ADDENDUM NO. 1
August 23, 2019

PSJA ISD Softball and Baseball Field Upgrades
PSJA ECHS ~ PSJA MEMORIAL ECHS ~ PSJA NORTH ECHS ~ PSJA SOUTHWEST ECHS
PHARR-SAN JUAN-ALAMO INDEPENDENT SCHOOL DISTRICT

PBK Project No.: 19141SP

CA 101

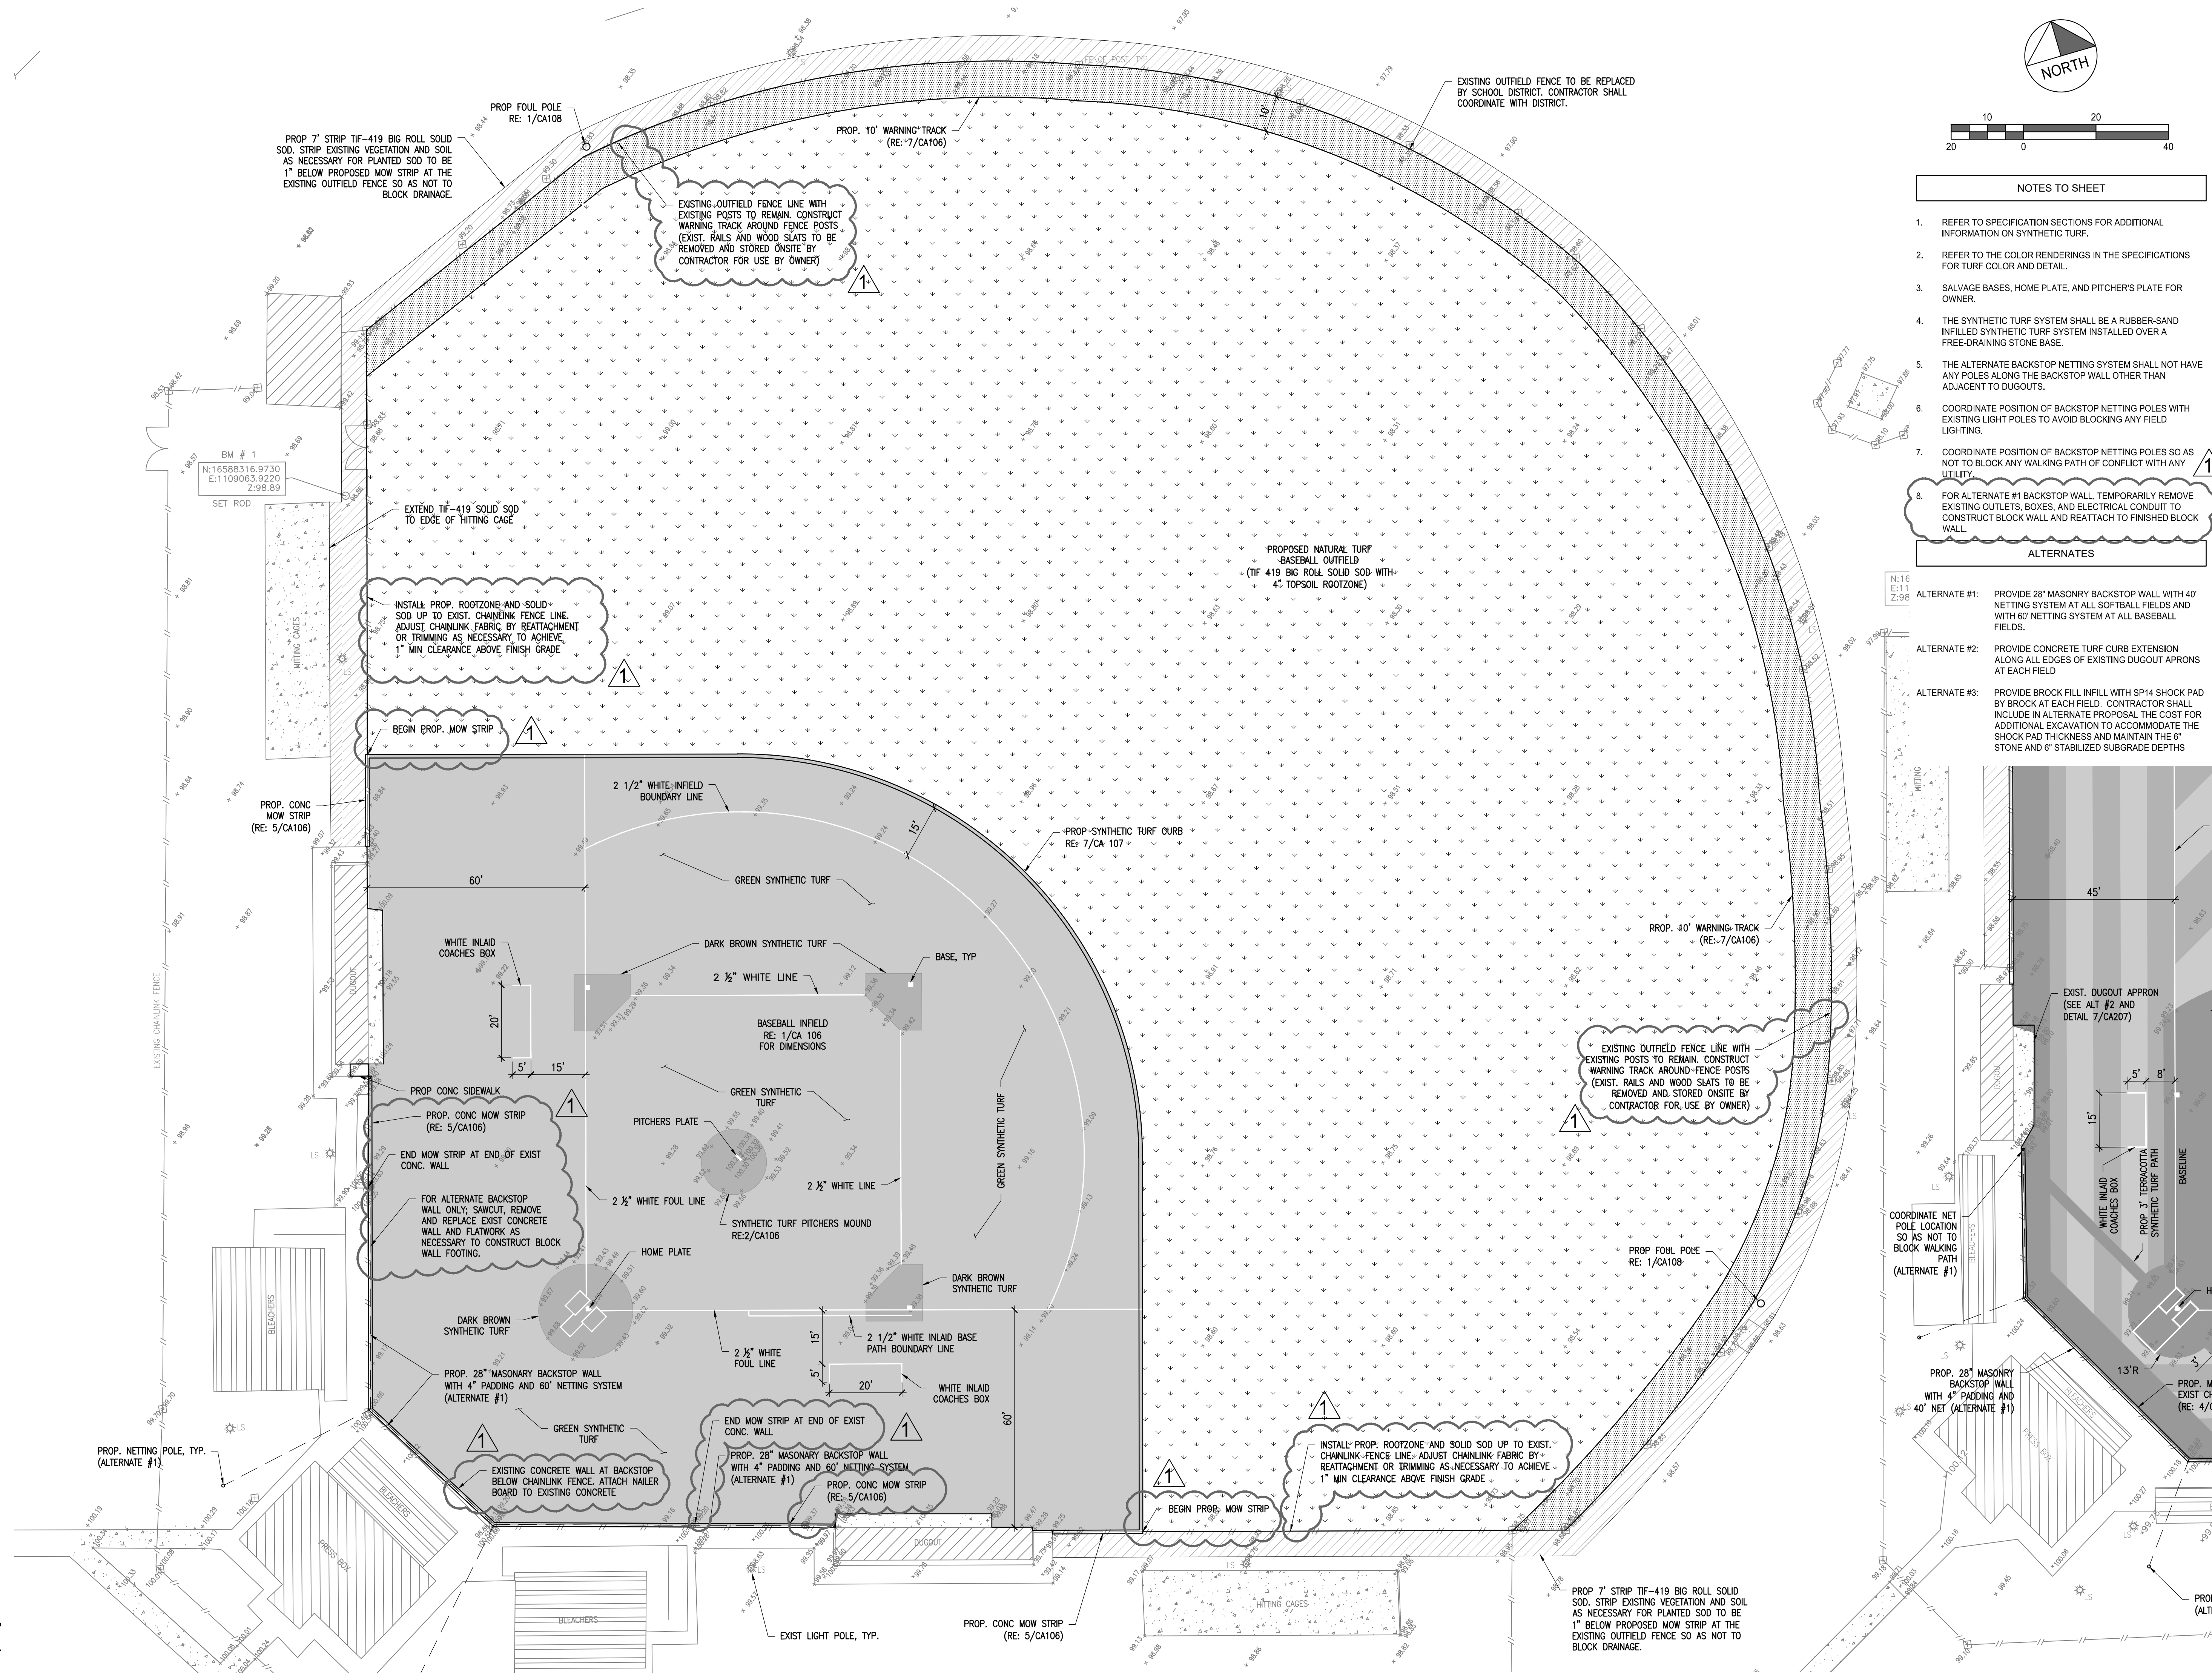
- Item No. 31 **CA 101 BASEBALL SITE PLAN**
Removed the mow strip linework in the outfield. Add fence and backstop labels for clarification. See attached.
- Item No. 32 **CA 205 SOFTBALL IRRIGATION PLAN**
Add pipe sizes, Quick Couplers and information on connection to existing irrigation main. See attached.

CA 205

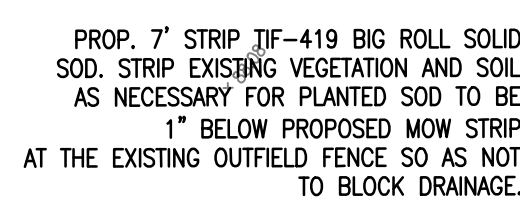
- Item No. 33 **CA 101 BASEBALL SITE PLAN**
Removed the mow strip linework in the outfield. Add fence and backstop labels for clarification. See attached.
- Item No. 34 **CA 205 SOFTBALL IRRIGATION PLAN**
Add pipe sizes, Quick Couplers and information on connection to existing irrigation main. See attached.

CA 101

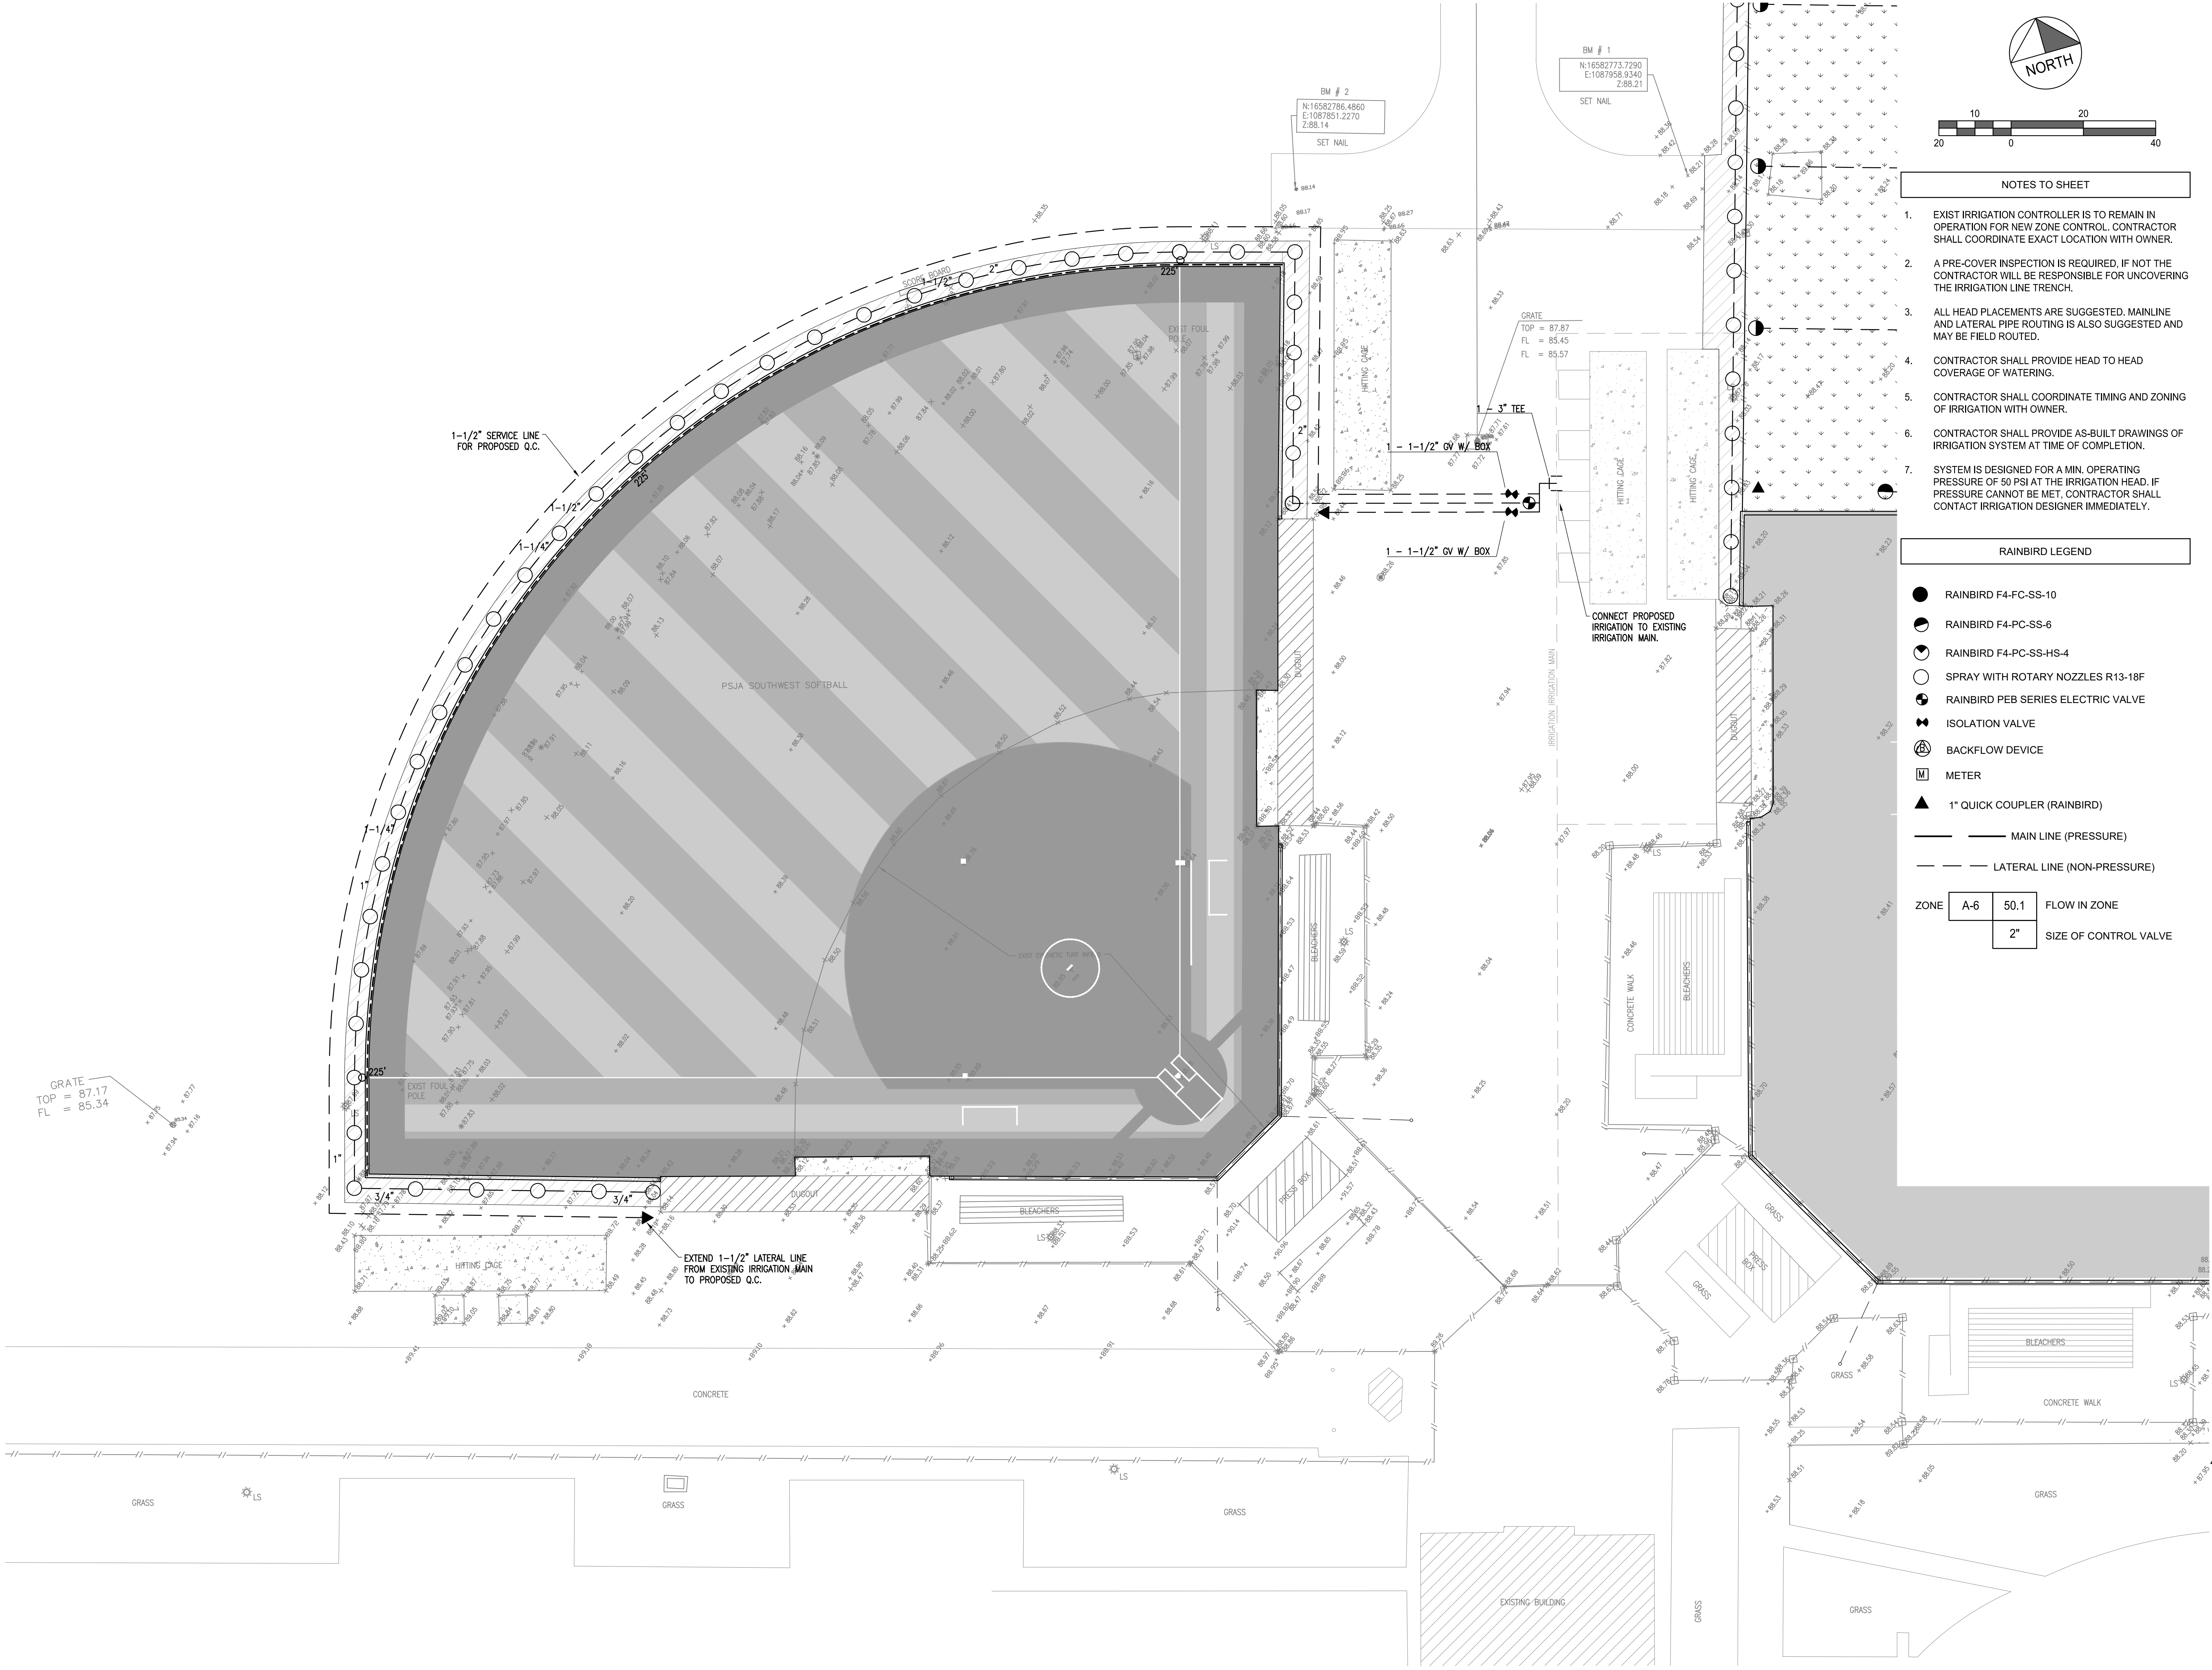
- Item No. 35 **CA 101 BASEBALL SITE PLAN**
Removed the mow strip linework in the outfield. Add fence and backstop labels for clarification. See attached.
- Item No. 36 **CA 205 SOFTBALL IRRIGATION PLAN**
Add pipe sizes, Quick Couplers and information on connection to existing irrigation main. See attached.
